Access Compliance Report

Public Rights-of-Way

(Curb Ramps)

Intersection ID: 31193	Main Street: DICKSON_LN	Cross Street: OLDEN_CT	Location: SE
ADA ID: DB19C6BB7CB6	Ramp Type: Perp	Initial Pass/Fail: Fail	Overall Compliance: No
Severity Score: 33.75			
Codes/Mitigation Info/Possible Solution		Field Measurements/Component Compliance

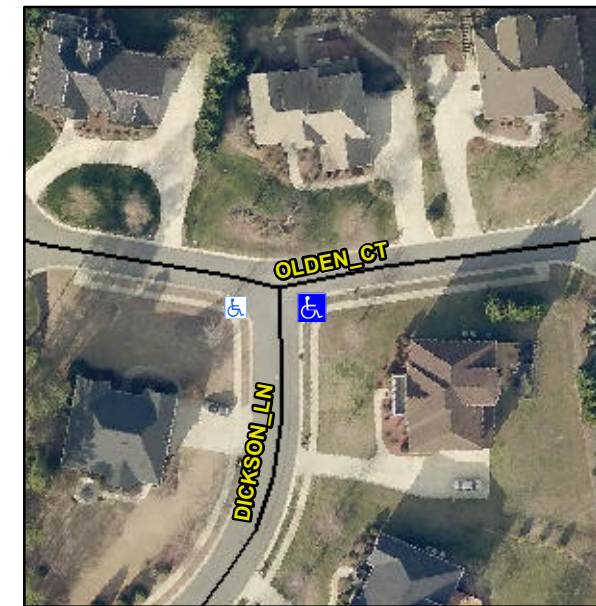
Not Found, R304.5.1, R304.2.2

Compliance	Description	Data	Compliance	Description	Data
N/A	Ramp Length (in)	46.0	No	Ramp Slope (%)	13.0
No	Ramp Width (in)	36.0	Yes	Ramp XSlope (%)	0.2
N/A	Flare Type LT	N/A	N/A	Flare Type RT	N/A
N/A	Flare Slope LT (%)	N/A	N/A	Flare Slope RT (%)	N/A
N/A	Flare Traversable LT?	N/A	N/A	Flare Traversable RT?	N/A
N/A	Landing Length (in)	N/A	N/A	DWS Provided?	N/A
N/A	Landing Width (in)	N/A	N/A	DWS Contrast?	N/A
N/A	Landing Slope (%)	N/A	N/A	DWS Length (in)	N/A
N/A	Landing X Slope (%)	N/A	N/A	DWS Full Width?	N/A
N/A	Landing Curb? (Y/N)	N/A	N/A	DWS Offset (in)	N/A
N/A	Shared Landing?	N/A			
N/A	Gutter Ponding?	N/A	N/A	Gutter Slope (%)	N/A
N/A	Gutter Lip Ht (in)	N/A	N/A	Gutter X Slope (%)	N/A
N/A	Painted X Walk1?	No	N/A	Painted X Walk2?	N/A
	X Walk 1 Direction	To W		X Walk 2 Direction	N/A
N/A	X Walk 1 Width (in)	N/A	N/A	X Walk 2 Width (in)	N/A
	X Walk 1 Slope (%)	1.4		X Walk 2 Slope (%)	N/A
	X Walk 1 X Slope (%)	0.4		X Walk 2 X Slope (%)	N/A

Remove & Replace Entire Ramp.
